ADDENDUM NO. 2

RFB #8496 Outfall Switchgear Replacement Project

This Addendum No. 2 shall be incorporated into and made part of the above referenced contract documents for RFB #8496.

SACRAMENTO REGIONAL WASTEWATER TREATMENT PLANT
X09 OUTFALL SWITCHGEAR REPLACEMENT PROJECT

ELECTRICAL
INTERIM MAIN SWITCHBOARD ONE-LINE AND ELEVATION

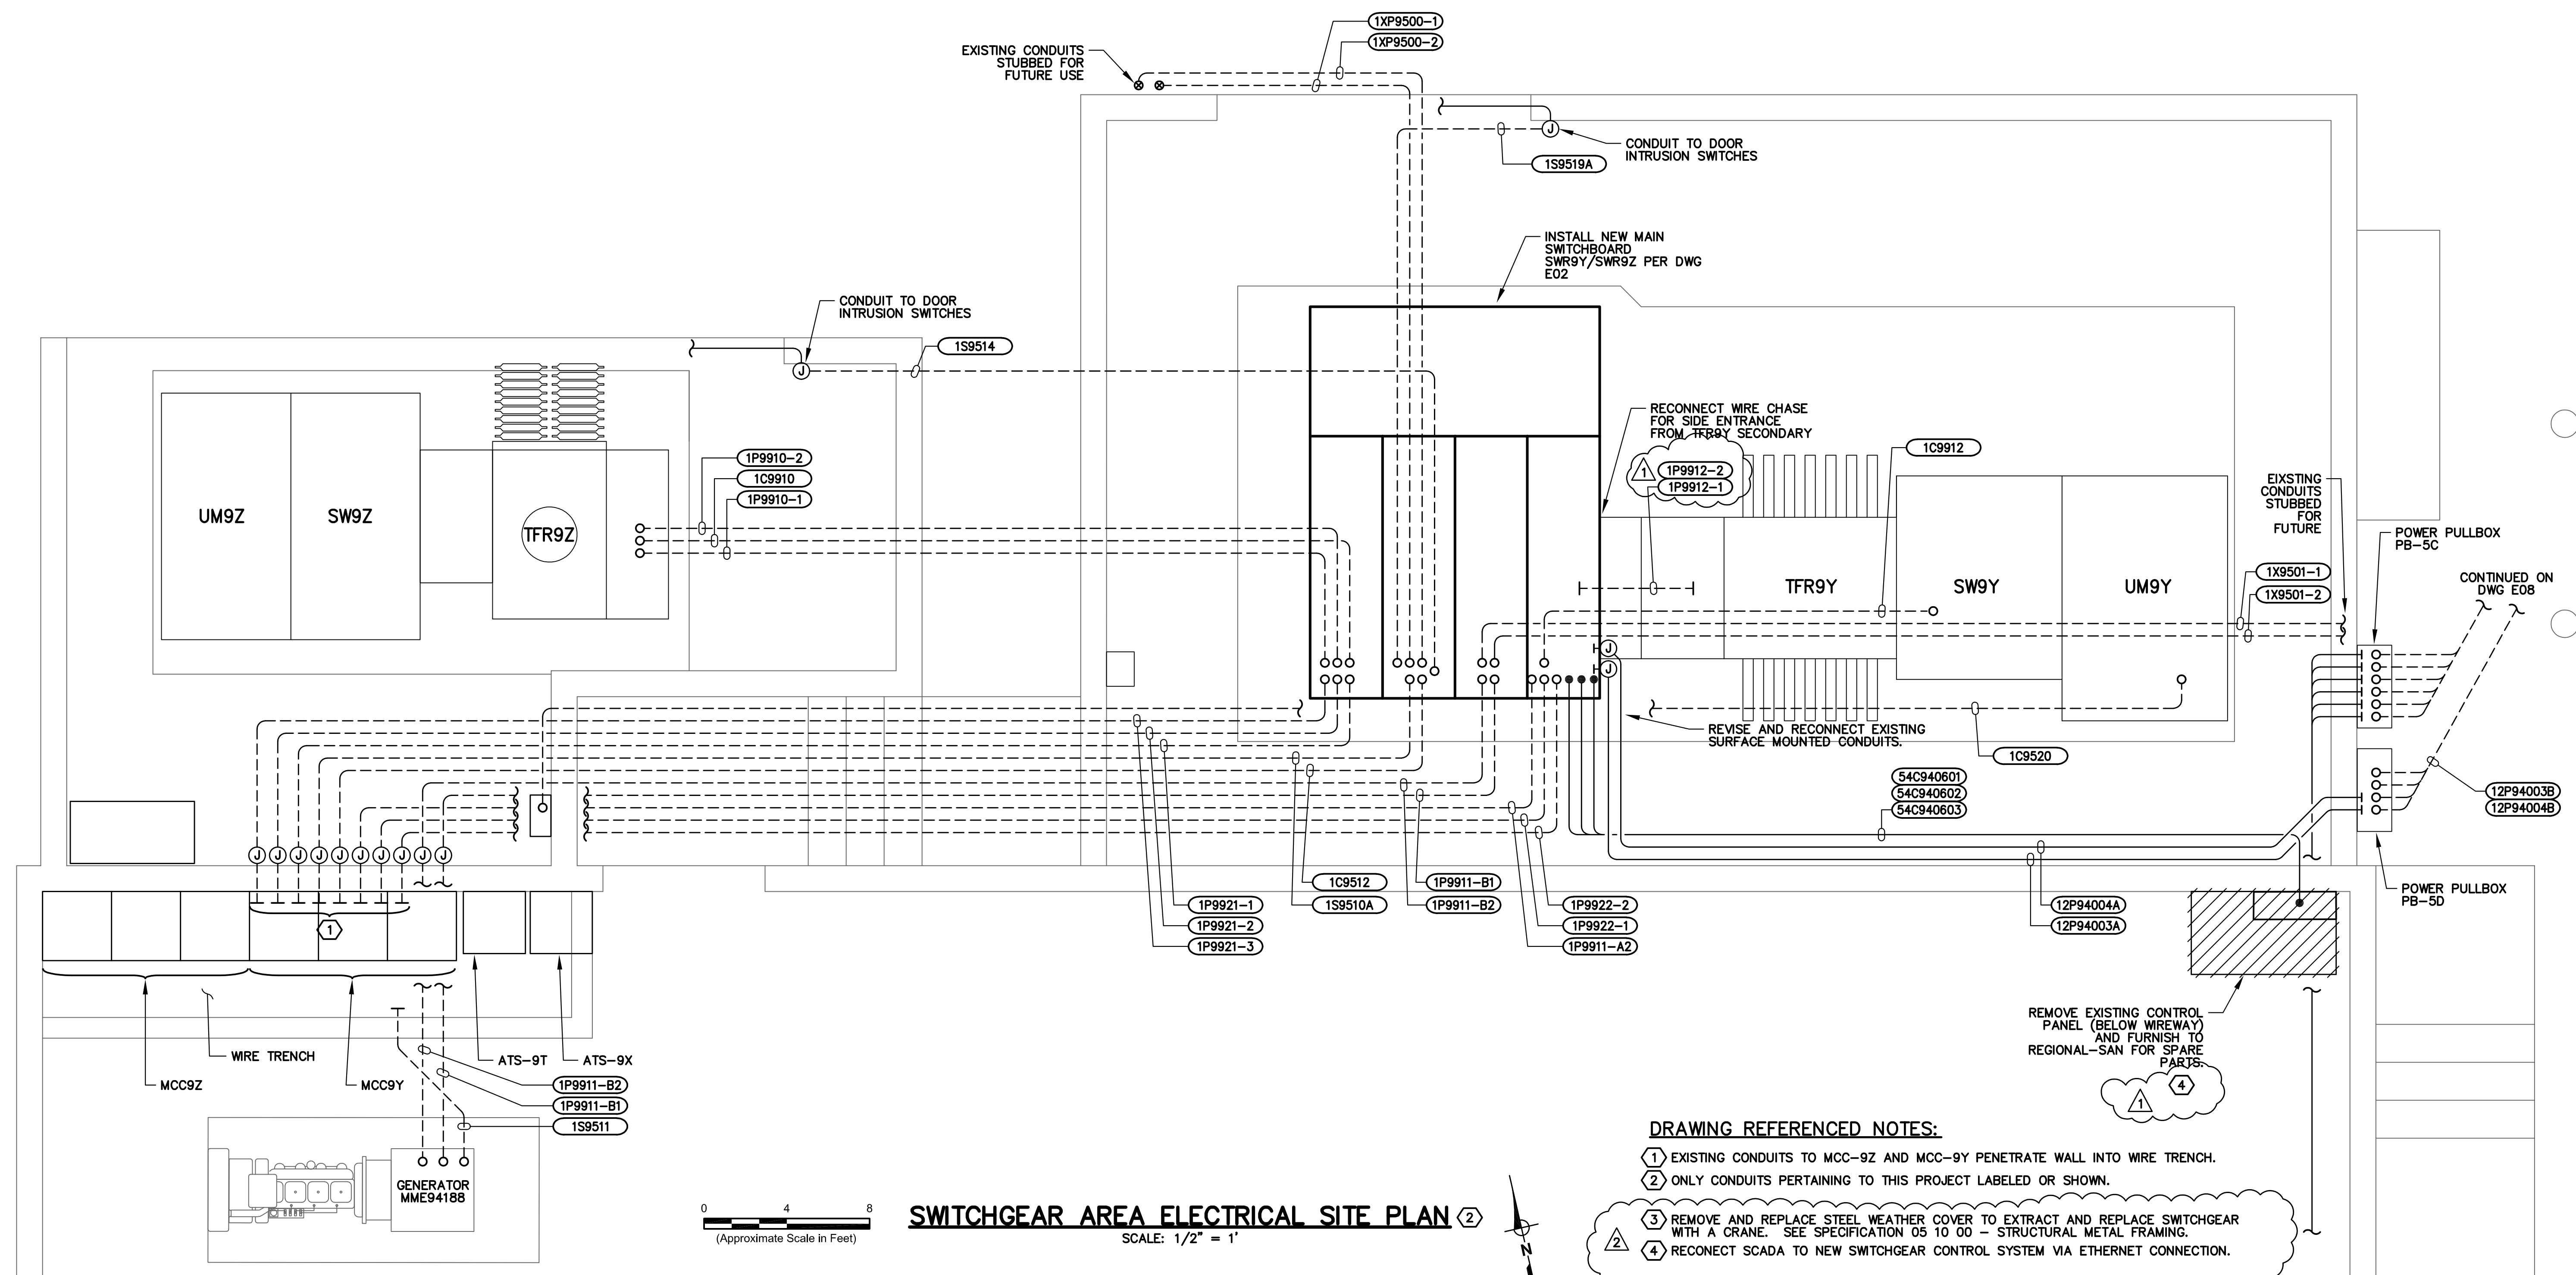
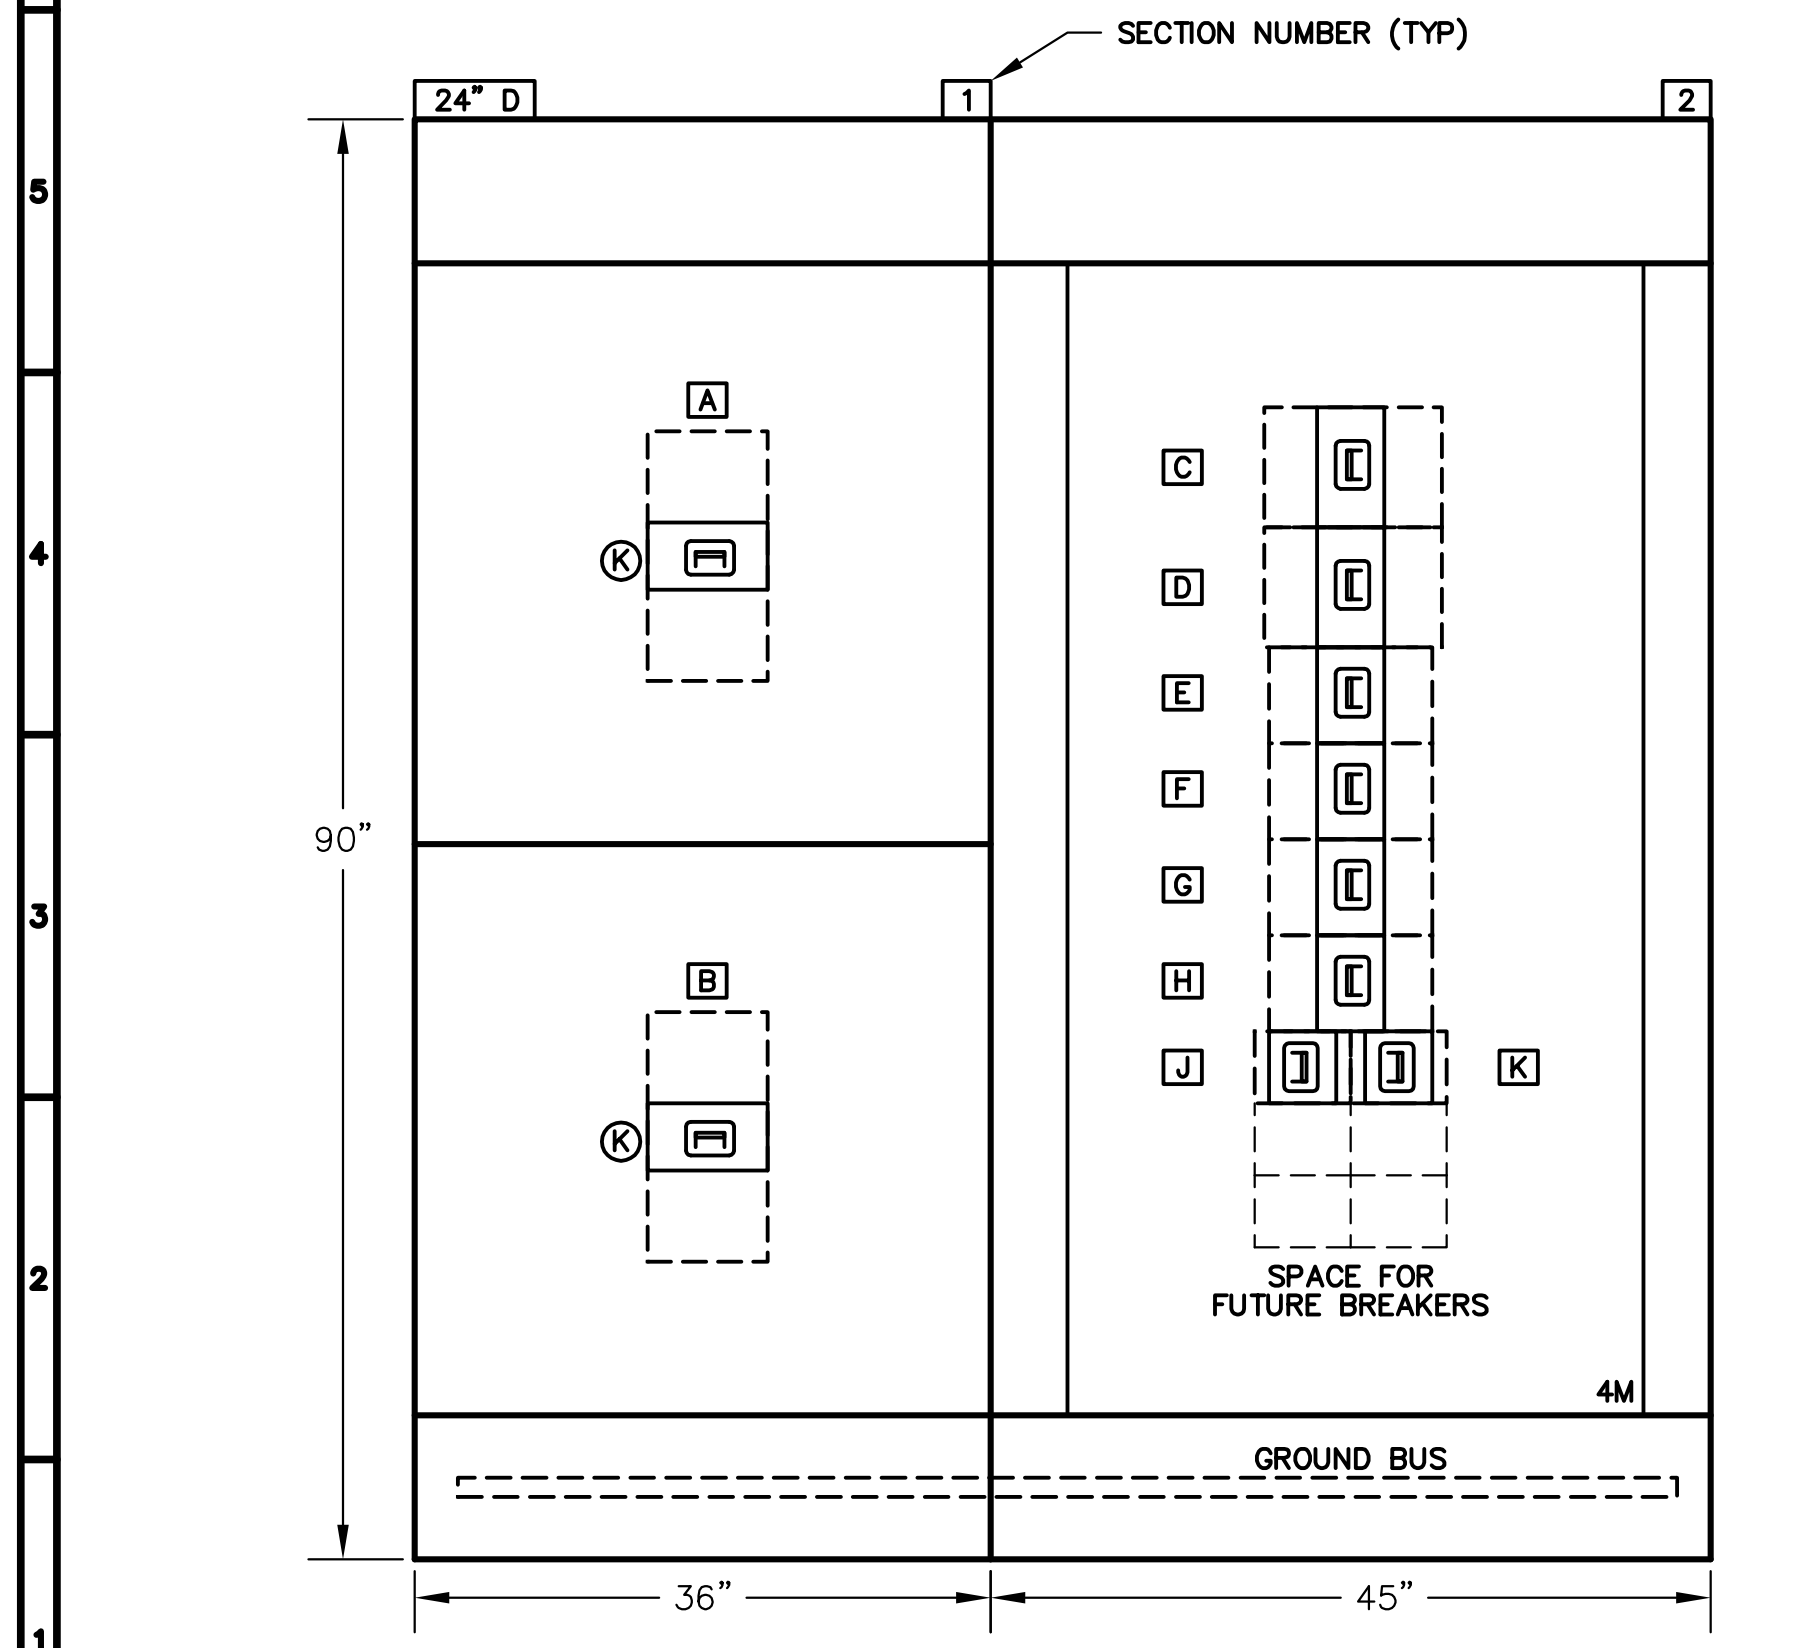
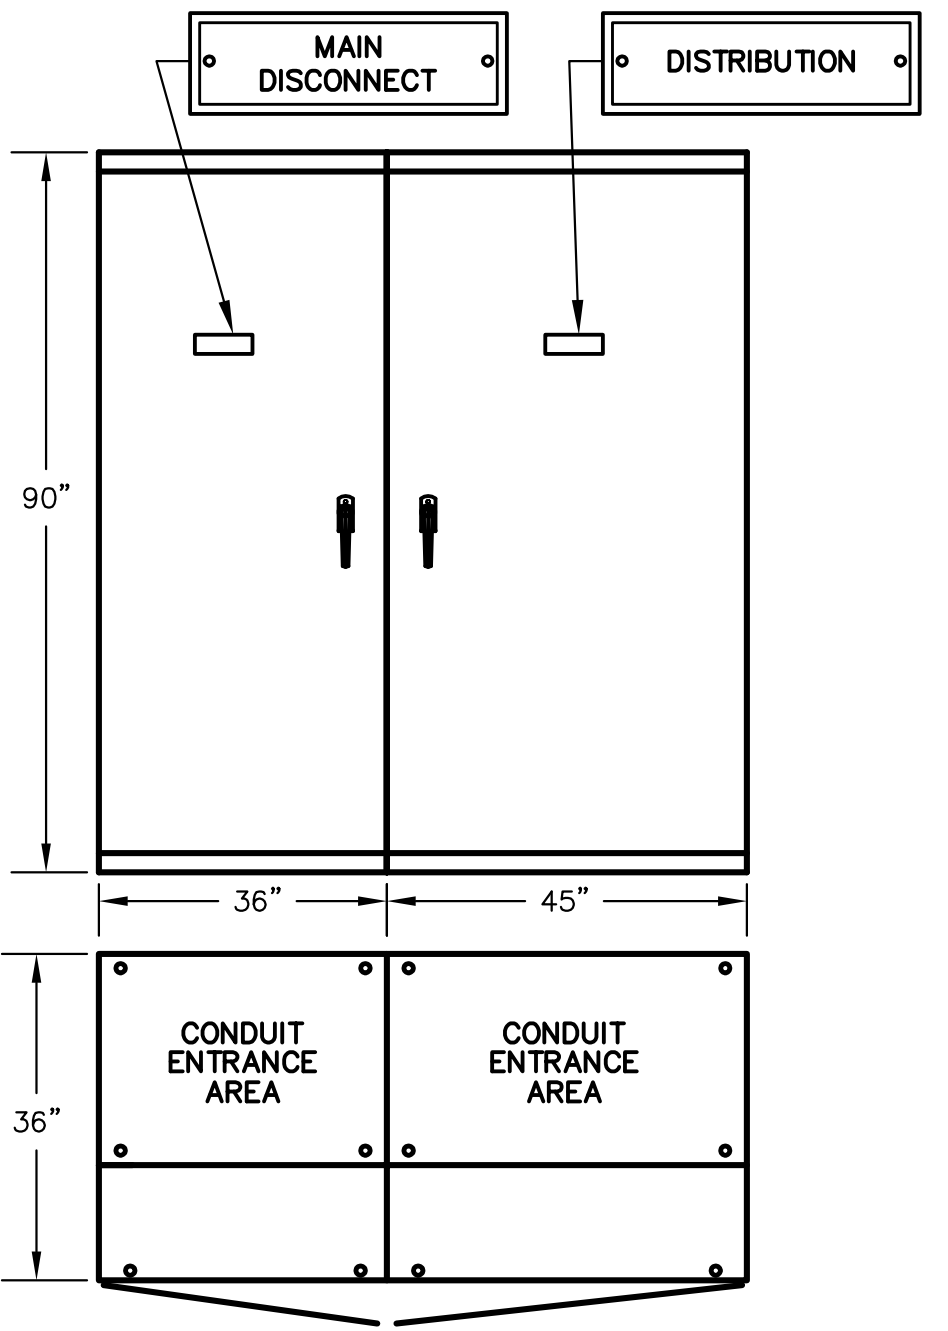
2.07	General Requirements	Portable (temporary) generator shall be contractor furnished, minimum 250 kW, 480/277V, 3P, 4W. Coordinate with Owner for location and refueling access.

1 PORTABLE (TEMPORARY) GENERATOR IS CONTACTOR FURNISHED TO SUPPORT FULL FACILITY OPERATION DURING TRANSITION PERIOD. ASSUME 250KW GENERATOR IS REQUIRED.

Yes. The temporary switchboard is intended to be a District-owned asset at the end of this project. The Contractor shall furnish a new interim switchboard in accordance with Section 26 24 13 and Drawing E04; rental switchgear is not acceptable. Upon successful cutover and acceptance of the permanent switchgear, the Contractor shall de-energize and disconnect the interim switchboard, remove all temporary feeders, supports, and associated temporary work, and deliver the switchboard with all accessories, O&M manuals, and test documentation to a District-designated on-site turnover location

ELECTRICAL SWITCHGEAR AREA ELECTRICAL SITE PLAN

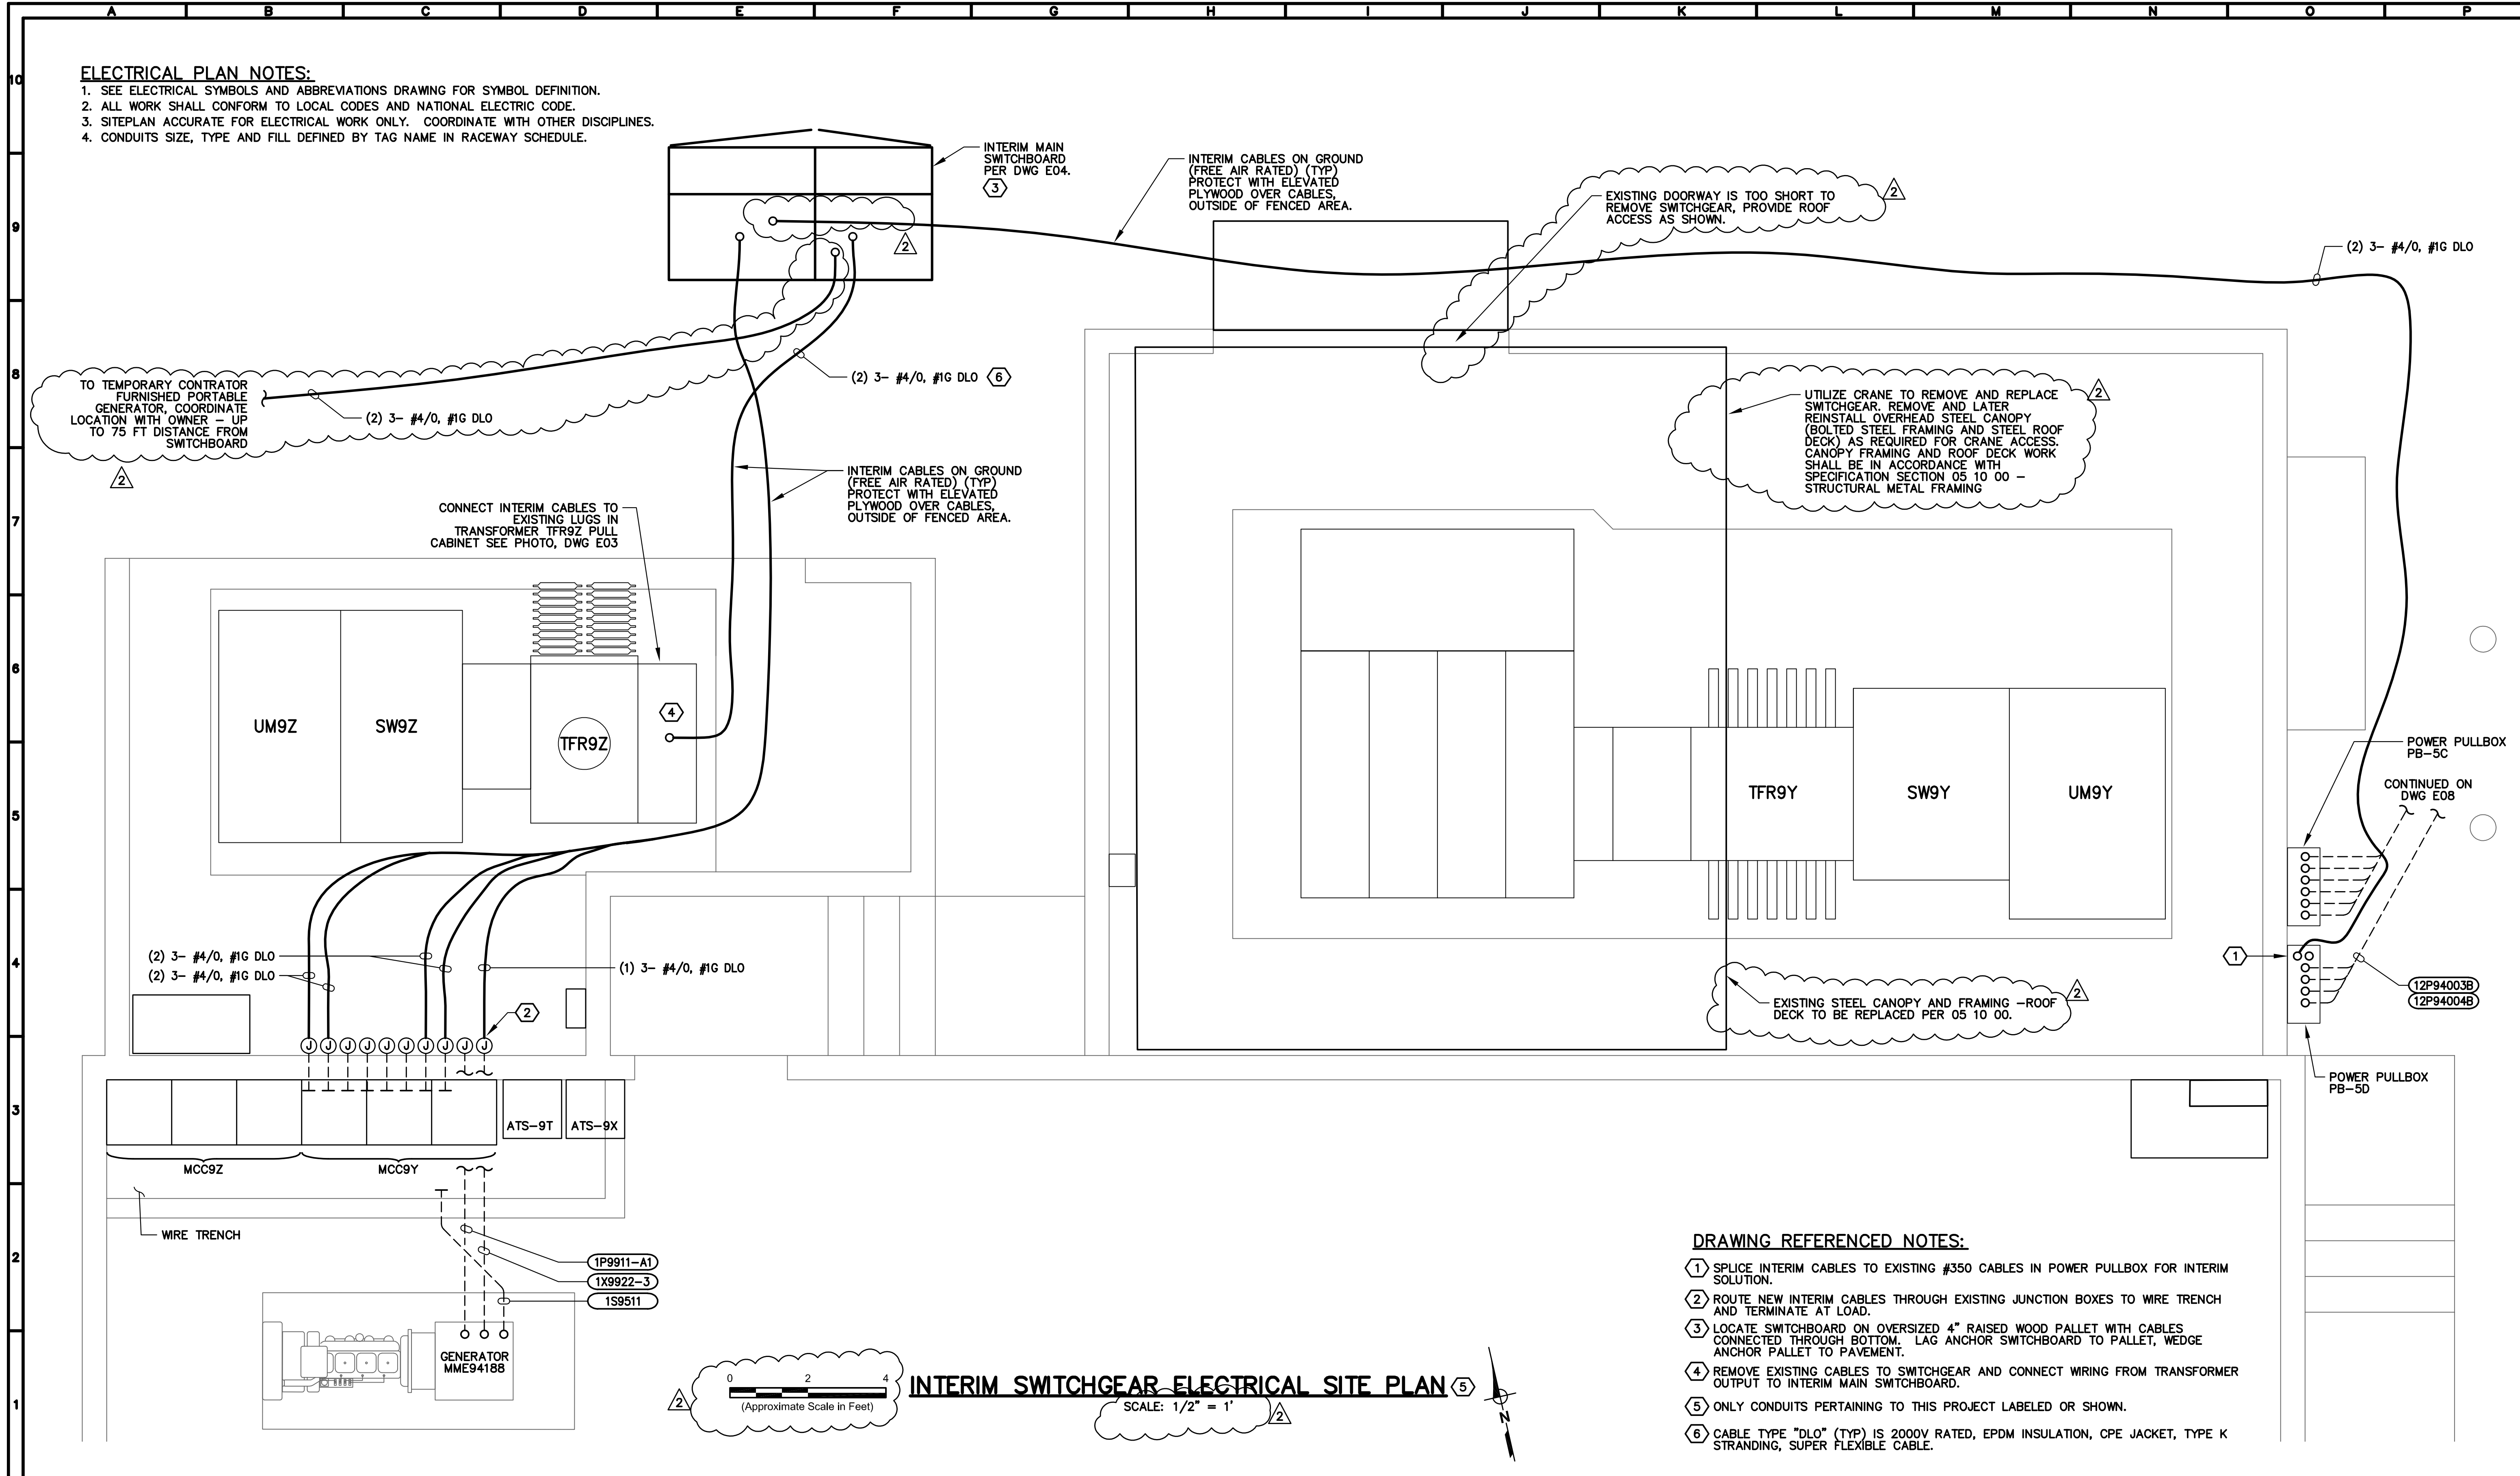
It appears that the scale of $\frac{1}{2}'' = 1'$ on drawing sheet E05 is incorrect. It should be $\frac{1}{4}'' = 1'$.

Please identify which conduits are to be new, and which ones are existing on sheet E05/E06. Currently everything on this sheet looks like it should be new. Notes are confusing at best.

The scale is correct
